VALUE ENGINEERING REPORT

SR 10 Loop / Atlanta Highway Interchange
NH-003-3(53), PI No 122890
Clarke County

August 10, 2007

ITEM N^o: A-7
CLIENT: GDOT
Sheet 2 of 3

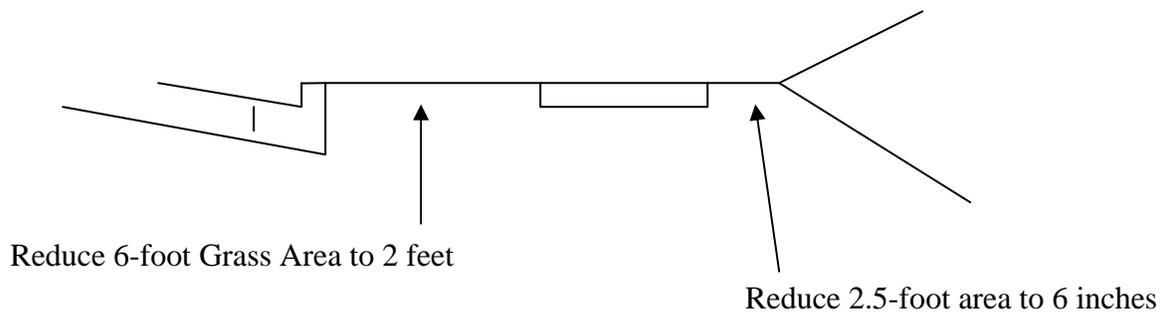
The current design provides for the construction of a 16-foot wide urban shoulder along Atlanta Highway and Huntington Road. The 16-foot shoulder width (from edge of pavement to the shoulder break) includes a 2.5-foot curb and gutter, a 6-foot grass buffer area between the back of curb and the sidewalk, a 5-foot sidewalk, and a 2.5-foot grass area outside the sidewalk.

It is recommended that the 16-foot urban shoulder width be reduced to 10 feet by reducing the width of the 6-foot grass buffer area to 2 feet and the 2.5-foot grass area outside the sidewalk to 6 inches.

ROW is the highest cost item on this project. Narrowing the shoulder width 6 feet on Atlanta Highway would reduce the amount of new ROW required to construct the project. Accepting this change would reduce the cost of the project and reduce its impact on the community. There will also be additional savings realized by the reduced earthwork, topsoiling and grassing of the narrower shoulder.

ITEM N^o: A-7A
CLIENT: GDOT
Sheet 2 of 3

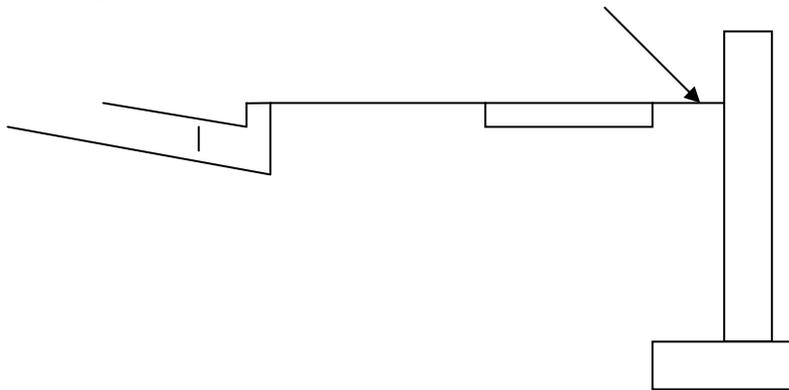
The current design provides for a 2.5-foot grass buffer area between the outside edge of the sidewalk and the inside edge of the retaining walls along Atlanta Highway and Huntington Road.

It is recommended that the 2.5-foot grass buffer area between the edge of the sidewalk and the inside edge of the retaining wall be eliminated.

ROW is the highest cost item on this project. This 2.5-foot reduction would result in less ROW being required to construct the project along the businesses adjacent to the mall. It would result in a potential cost savings to the project and reduce the project's impact on local businesses.

Eliminate Grass Area Between Sidewalk & Wall

ITEM N^o: B-12
CLIENT: GDOT
Sheet 2 of 3

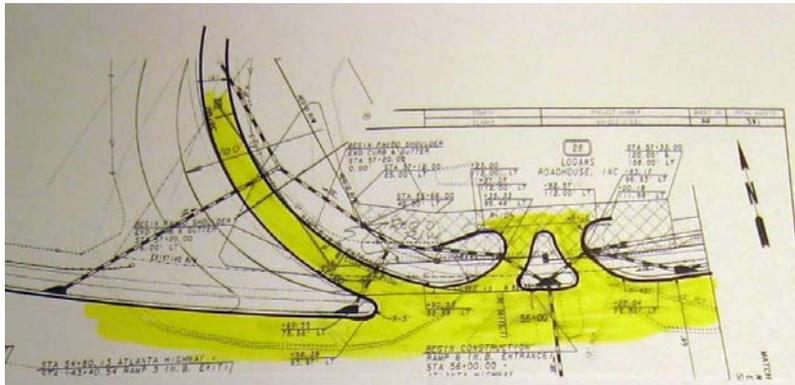
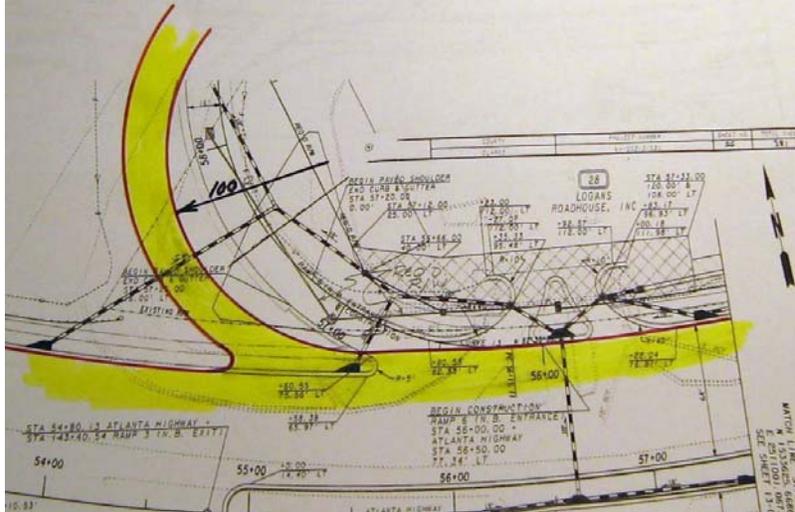
The current concept proposes to use a 134-foot radius curve for the eastbound right turn movement from Atlanta Highway into the SR 10 northbound on ramp.

It is recommended that the on ramp location be shifted slightly to the west and use a 100-foot radius curve.

Shifting the ramp location to the west and changing to a 100-foot radius curve will provide greater separation between the ramp gore and the right-in / right-out driveway on the Logans' parcel and improve safety. It will also reduce the amount of ROW required from the parcel. This concept will reduce the project's impact on the Logans parcel and result in a potential cost savings.

ITEM N^o: B-7A
CLIENT: GDOT
Sheet 2 of 3

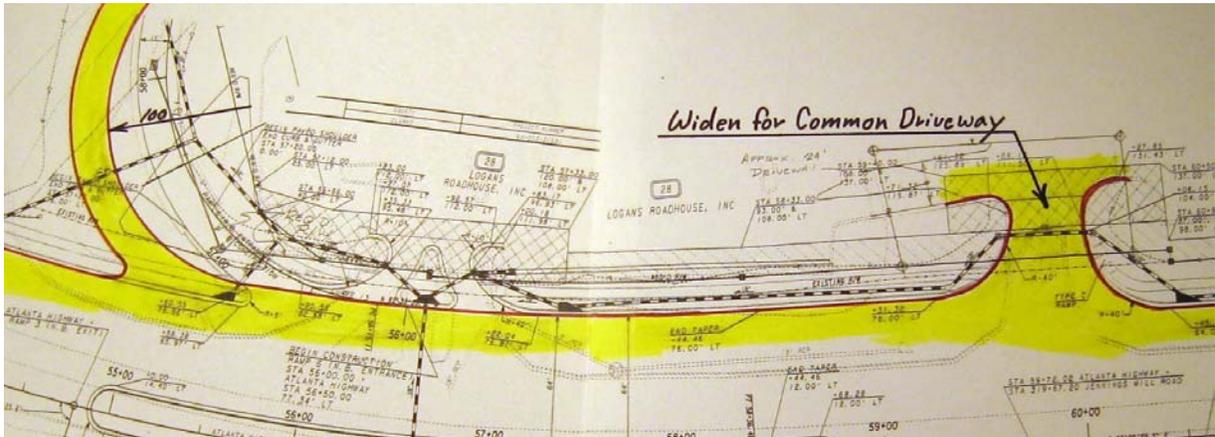
Original Concept: The current design proposes to convert the existing full access driveway into a right-in / right-out driveway at the beginning of the northbound SR 10 on ramp.

Proposed Change: It is recommended that the Logans driveway be closed and that new access be provided through a wider “common driveway” that would serve both the Logans’ property and the adjacent property.

Justification: Maintaining an access driveway anywhere along the Logans’ property line will negatively impact the right turn movement for vehicles entering the northbound SR 10 on ramp and pose a safety hazard. The construction of any driveway along Logan’s property line would be very close to the proposed new Atlanta Highway median openings for Ramp 3 and for relocated Jennings Mill Road. This situation could lead to vehicles exiting Logans to attempt to cross the four lanes of Atlanta Highway to make a U-turn at the Ramp 3 median opening in order to travel eastbound, or for vehicles to attempt to drive the wrong way on Atlanta Highway and cross at the Jennings Mill Road opening.

Maintaining any driveway on the Logan property will result in potential serious safety issues. Providing access to the Logan property through a wider “common driveway” from the adjacent property would greatly improve safety. The “common driveway” would be located directly opposite the relocated Jennings Mill Road entrance, be at a signalized intersection, and allow for both left and right turns.

C-2 Option 2-Span (2 @ 93 feet) with "U" MSE Wall Option

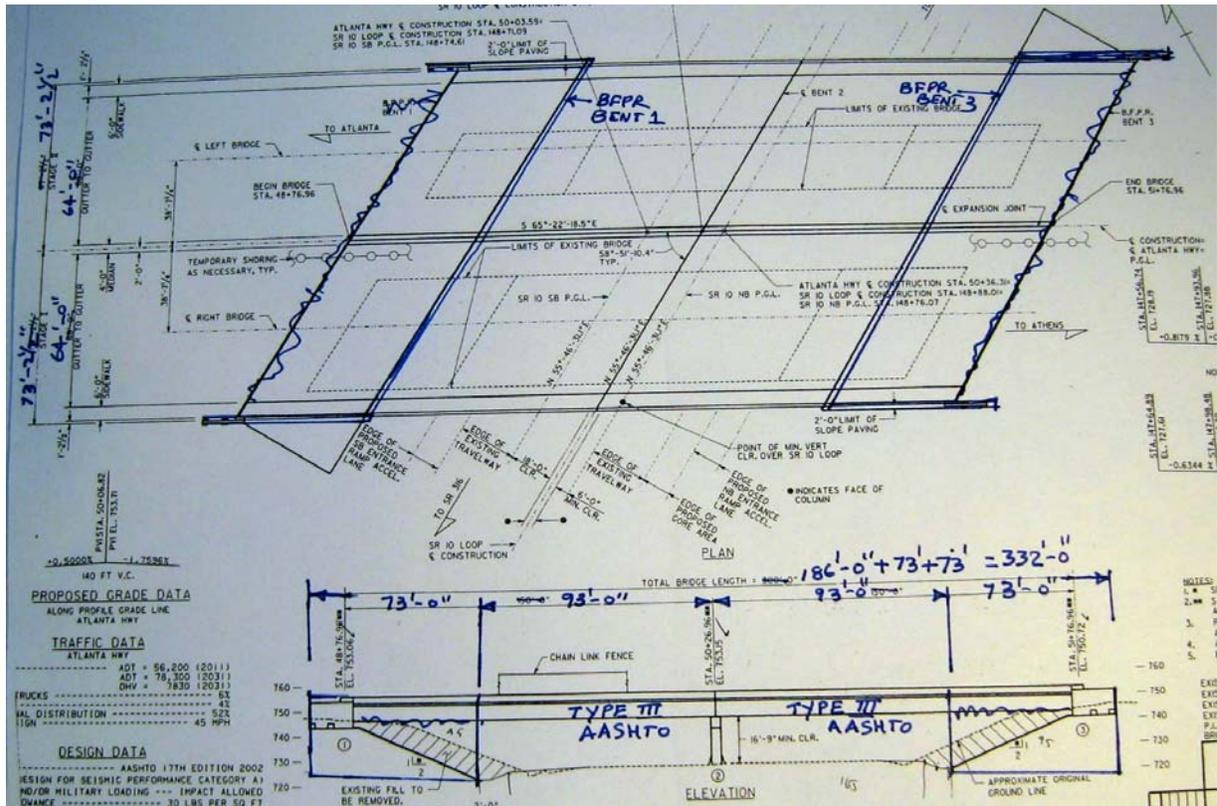
The current bridge layout consists of a two-span (2 @ 150'-0”) structure with Bulb-Tee 74” PSC beams. The structure included a median pier and side slopes with end bents. The construction of the median pier will involve significant traffic control and shifting of lanes on SR 10.

It is recommended the bridge layout be changed to a two-span (2 @ 93'-0”) structure with Type III AASHTO PSC beams and two “U” shaped MSE walls at the abutment ends. In addition, the bridge width should be reduced 8 feet by eliminating the Bike Lanes on both sides. This concept would improve constructability through the use of MSE wall construction at the abutments, the use of smaller Type III beams, a reduction in the amount of embankment needed for the structure, and the reduction in bridge width. Removing the bike lanes from the dual 5-lane structures will improve safety. The current design places the bike lanes in direct conflict with merging traffic trying to enter the right turn lanes for the SR 10 loop ramps. This concept would result in a reduction in construction time and result in significant cost savings to the project.

C-2A Option 1-Span (165 feet) with "U" MSE Wall Option

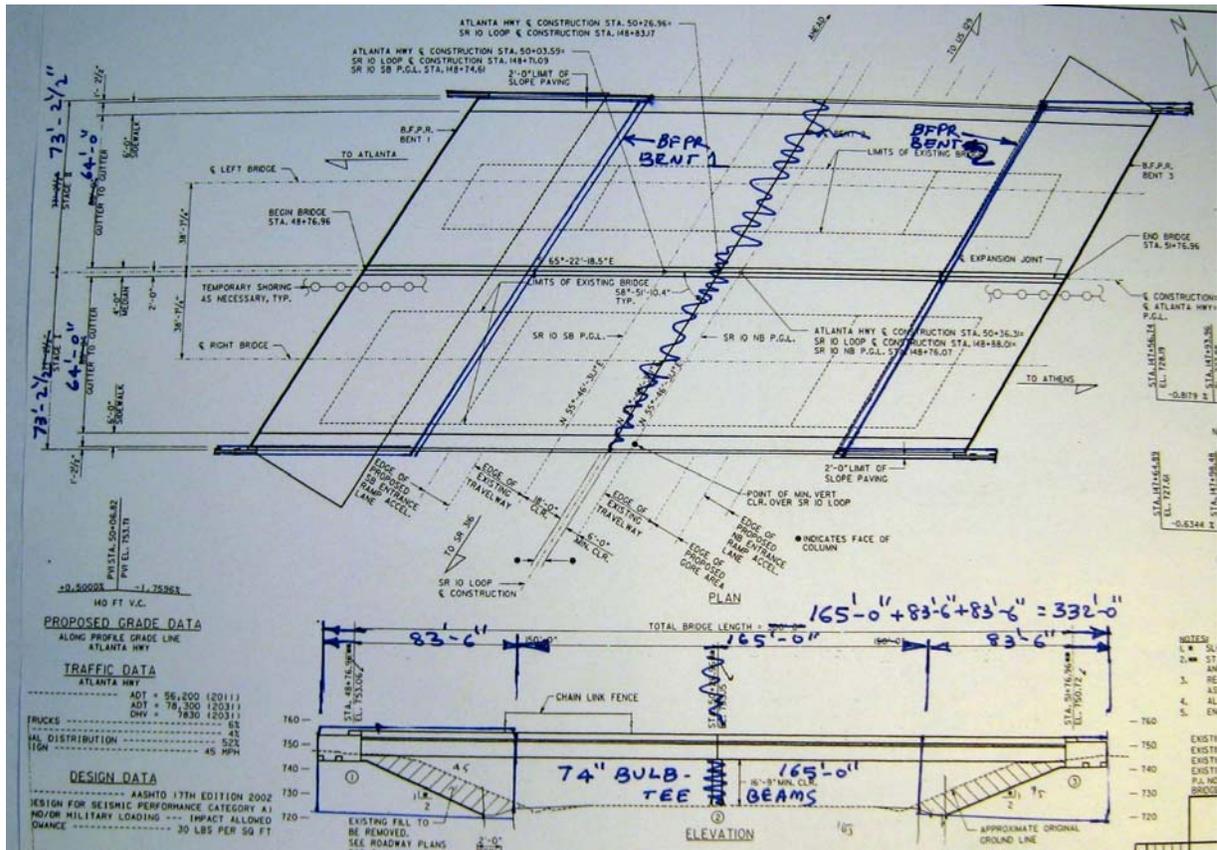
This alternative recommendation would change the bridge layout to a one-span (165'-0”) structure with 74” Bulb-Tee PSC beams and two “U” shaped MSE walls. In addition, the bridge width would be reduced 8 feet by eliminating the Bike Lanes on both sides. This concept would not require the construction of a median pier because the 74” Bulb-Tee beams can span 165'-0” thereby eliminating the need for a median pier. This arrangement results in savings in traffic control and signage since there is no need for a median pier. Removing the bike lanes from the dual 5-lane structures will improve safety. The current design places the bike lanes in direct conflict with merging traffic trying to enter the right turn lanes for the SR 10 loop ramps. This concept would result in cost savings to the project, however, working with the larger beam lengths may present constructability issues. This concept would also place the abutments closer to the edge of shoulder than alternate C-2.

C-2B Option 4-Span (2 @ 57 feet & 2 @ 93 feet)
 type 2 type 3

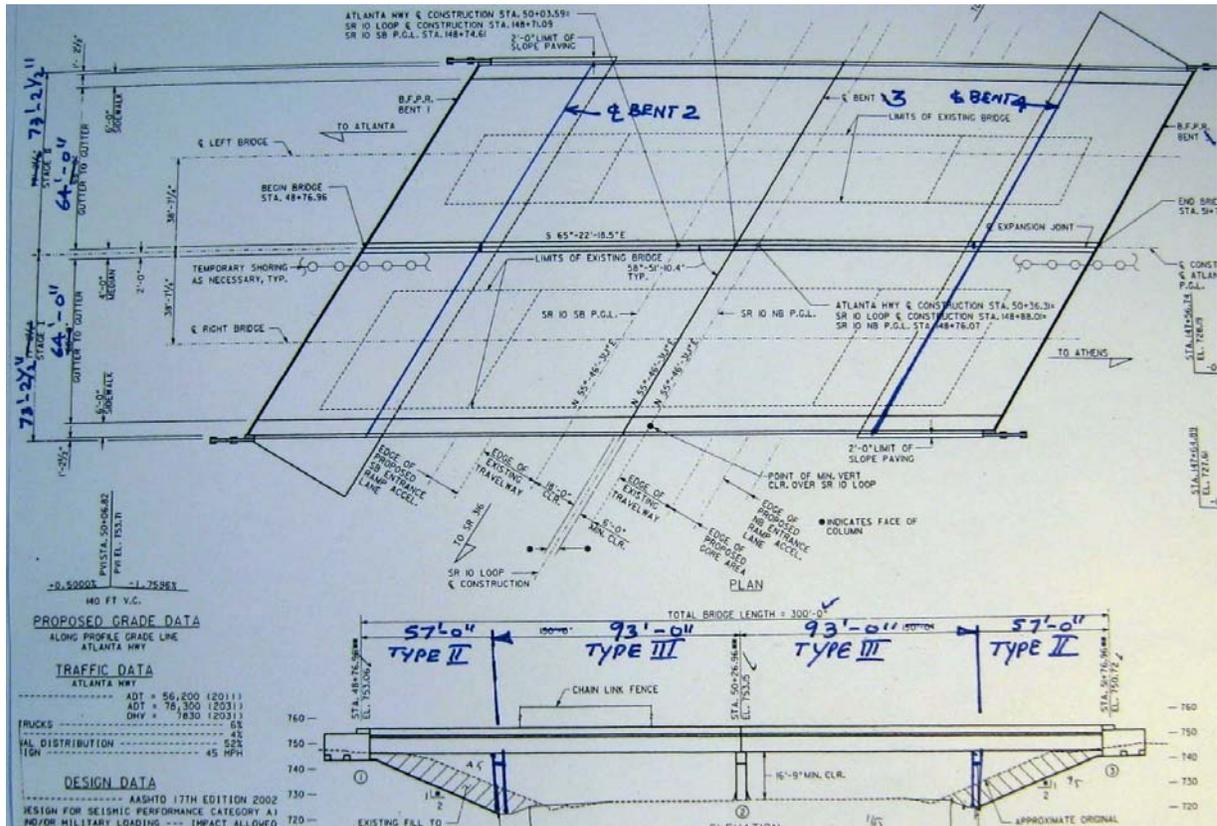
This alternative recommendation would change the bridge layout to a four-span (2 @ 57 feet and 2 @ 93 feet) structure with Type III and Type II AASHTO PSC beams. In addition, the bridge width would be reduced 8 feet by eliminating the Bike Lanes on both sides. This bridge concept would improve constructability through the use of smaller Type III and Type II beams, a reduction in the amount of embankment needed for the structure, and the reduction in bridge width. Removing the bike lanes from the dual 5-lane structures will improve safety. The current design places the bike lanes in direct conflict with merging traffic trying to enter the right turn lanes for the SR 10 loop ramps. This concept would replace the MSE wall abutment configuration suggested in Alternative 2-C above with simple spans and result in two additional bridge joints. It would result in a cost savings to the project.

This concept would replace the MSE wall abutment configuration suggested in alternative 2-C above with simple spans. This concept would result in two additional bridge joints. It would result in a cost savings to the project.

C-2C Option 3-Span (2 @ 67'-6" & 1 @ 165 feet)
 Type 3 BT 74

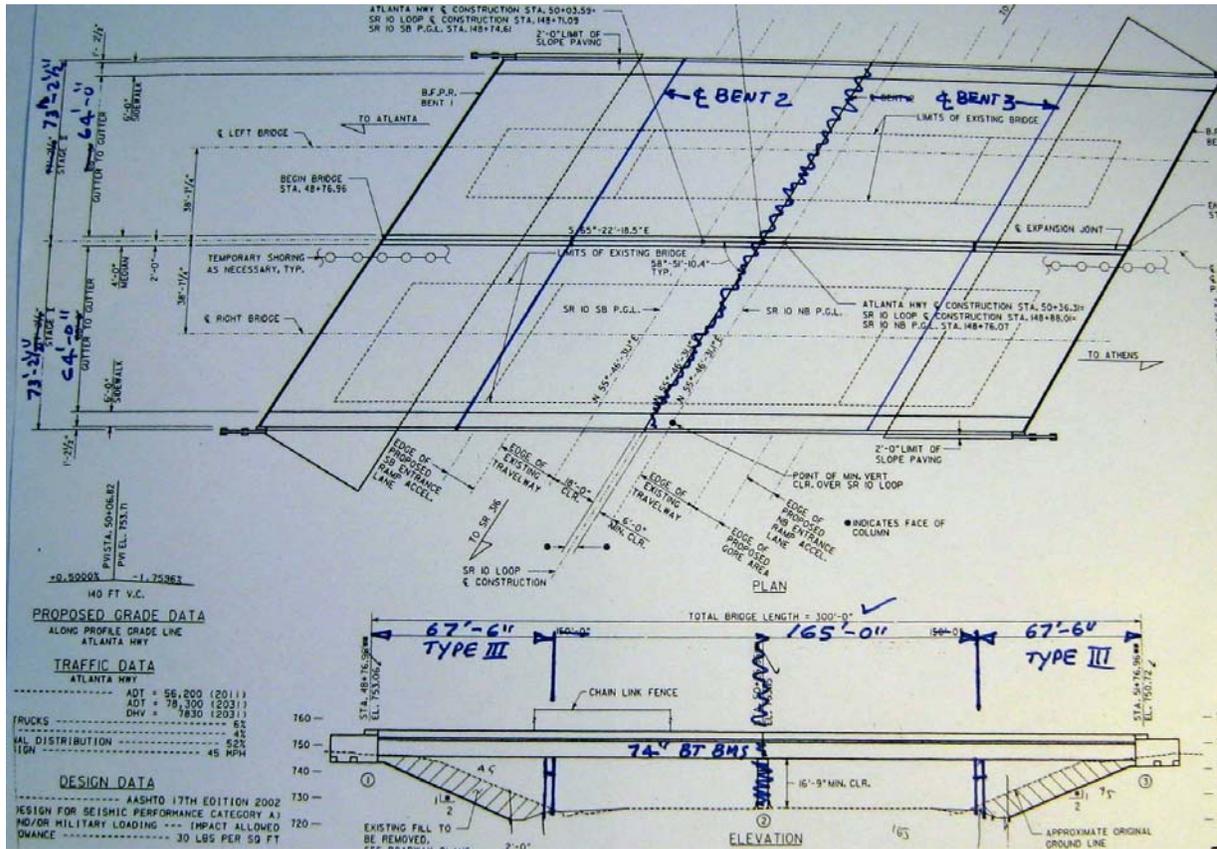
This alternative recommendation would change the bridge layout to a three-span (2 @ 67'-6" and 1 @ 165 feet) structure with 74" Bulb-Tee beams and Type II AASHTO PSC beams. In addition, the bridge width would be reduced 8 feet by eliminating the Bike Lanes on both sides. This concept would not require the construction of a median pier because the 74" Bulb-Tee beams can span 165'-0" thereby eliminating the need for a median pier. This arrangement results in savings in traffic control and signage since there is no need for median pier. Removing the bike lanes from the dual 5-lane structures will improve safety. The current design places the bike lanes in direct conflict with merging traffic trying to enter the right turn lanes for the SR 10 loop ramps. This concept would result in cost savings to the project, however, working with the larger length beams may present constructability issues. This concept would place the abutments closer to the edge of shoulder than Alternate C-2.
